Addendum #1

Issued June 27, 2024

The following information changes the competitive process documents issued on June 20, 2024.

SITE GRADING & SERVICING PLAN

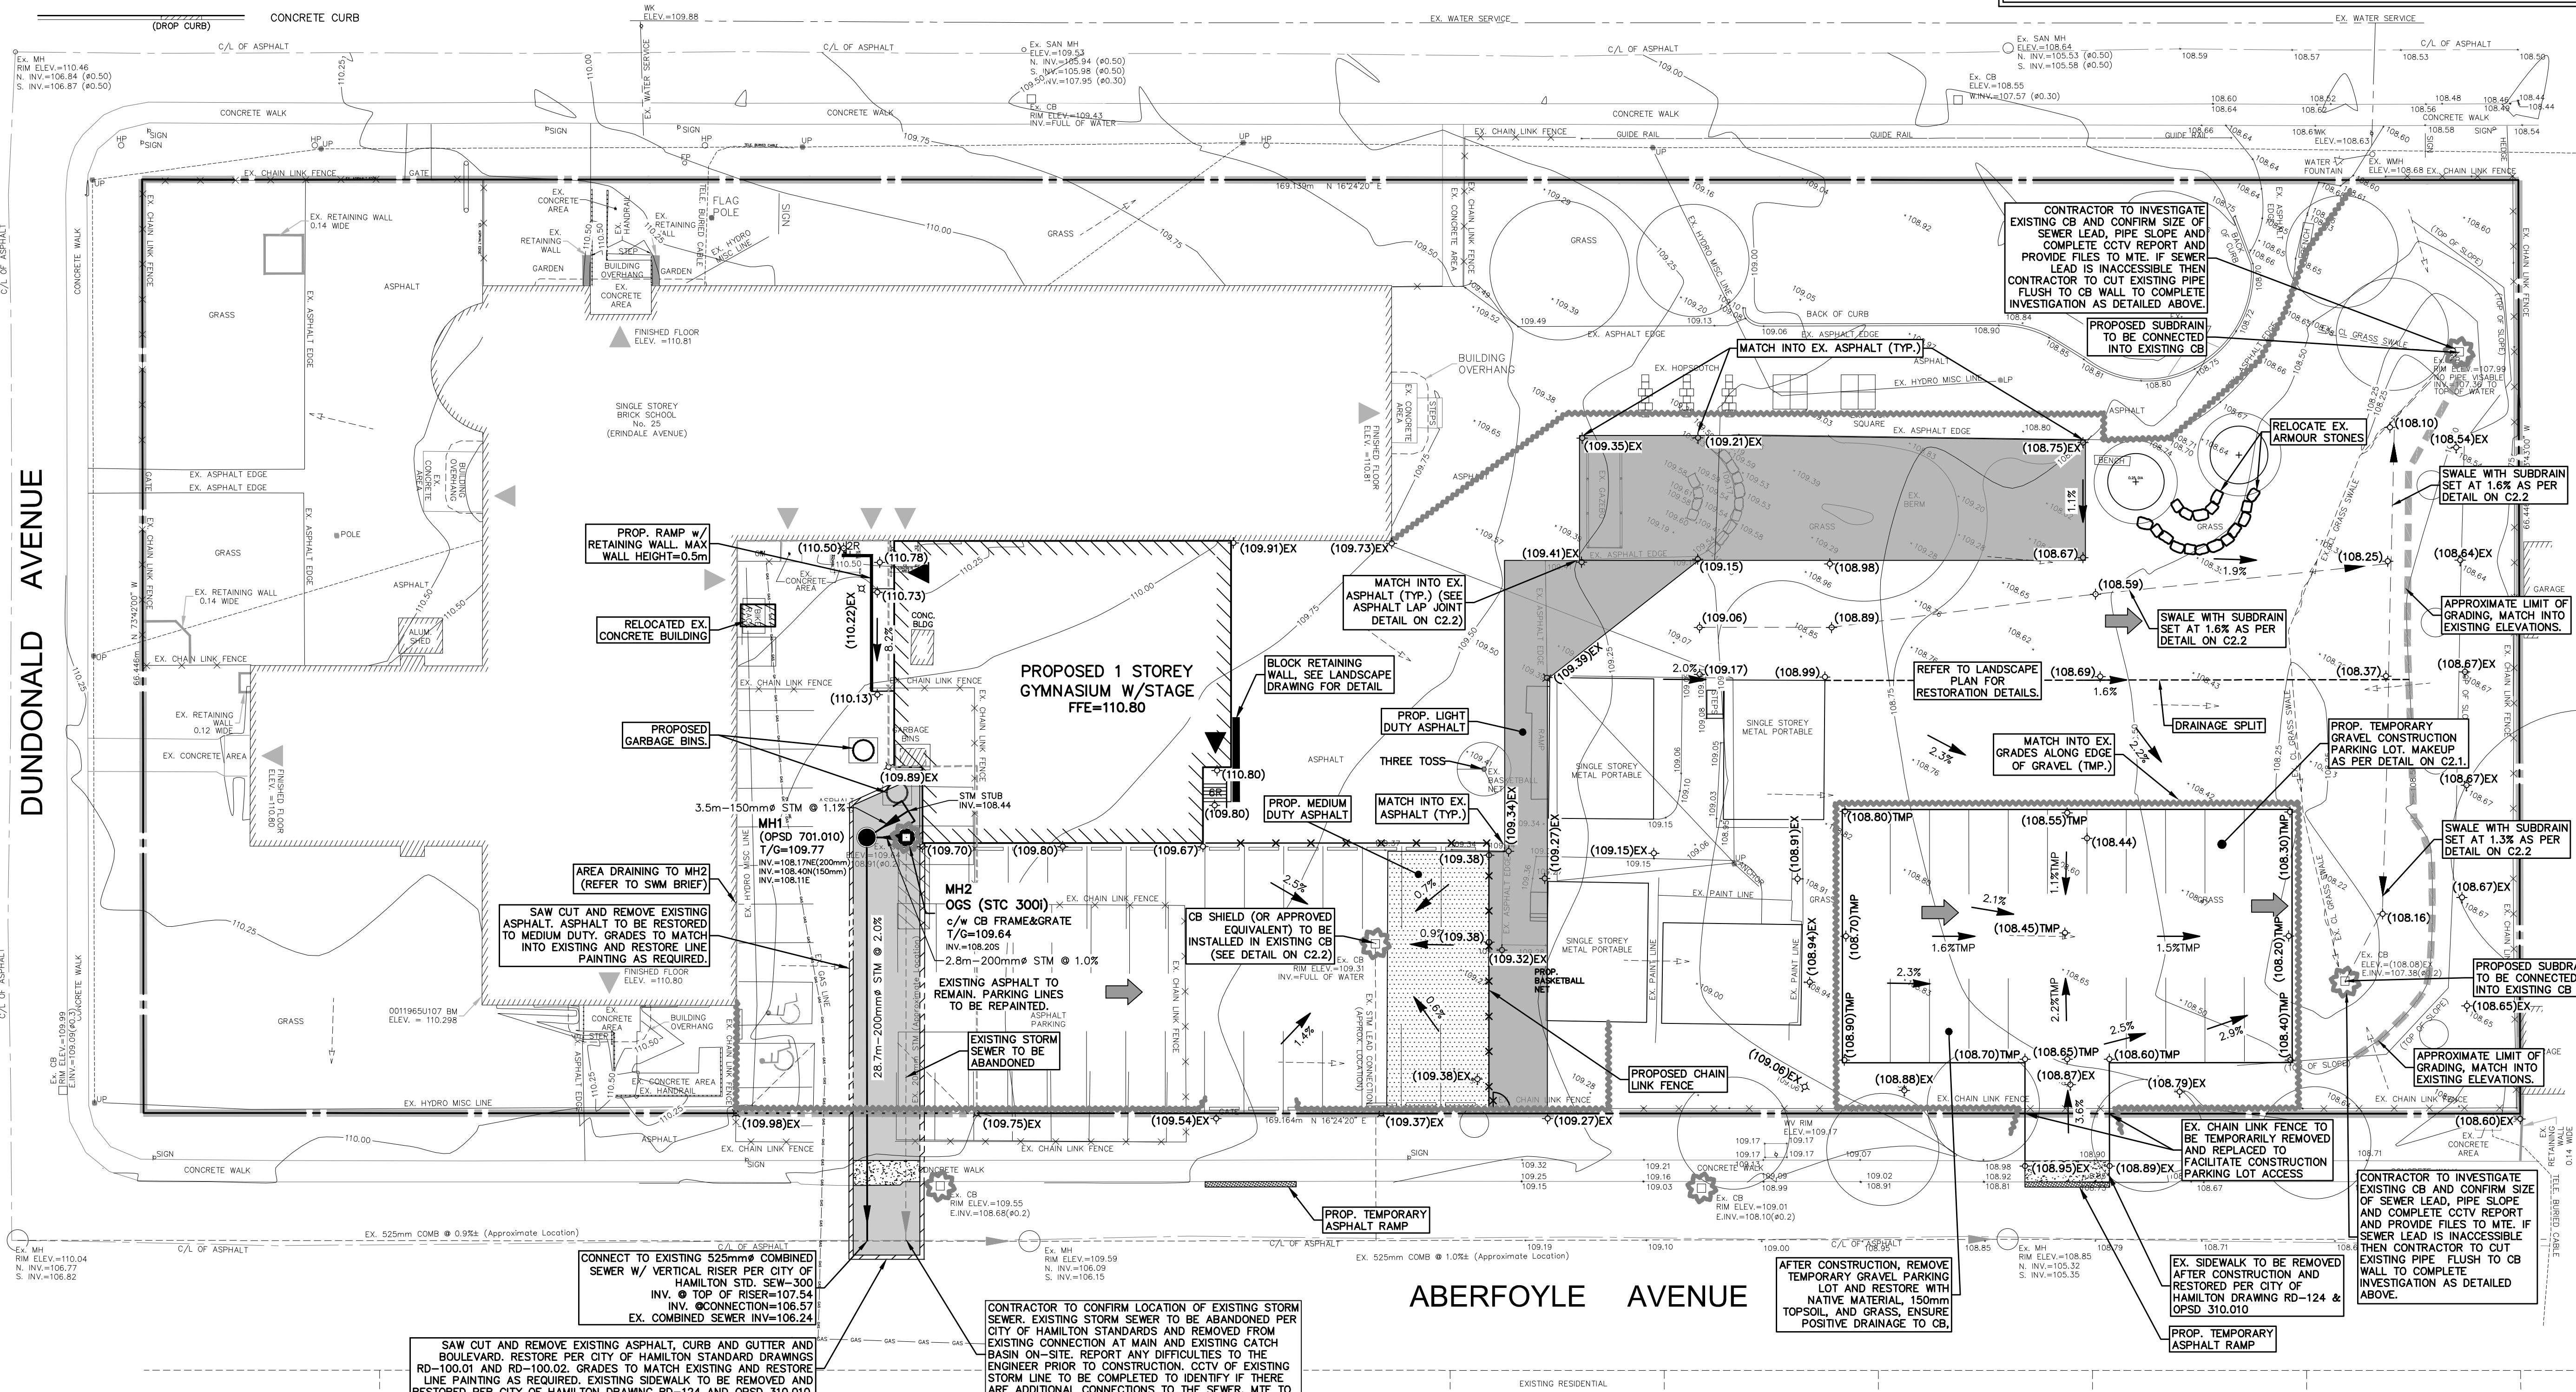
- R4 **We do not have enough information to accept Funktion VSport 710 as an equal at this time.**
- Q5 Please provide grading plan that was properly printed to PDF from AutoCAD. Provided grading plan was scanned from original PDF. Scanned versions of the drawings restricts us to upload them to AutoCAD for grading calculations.

- R5 **Provided grading plan includes all information required to prepare a bid for this project.**
- Q6 A lot of the requirements for lighting are to be coordinated with the BAS. Please clarify who is the existing BAS vendor.
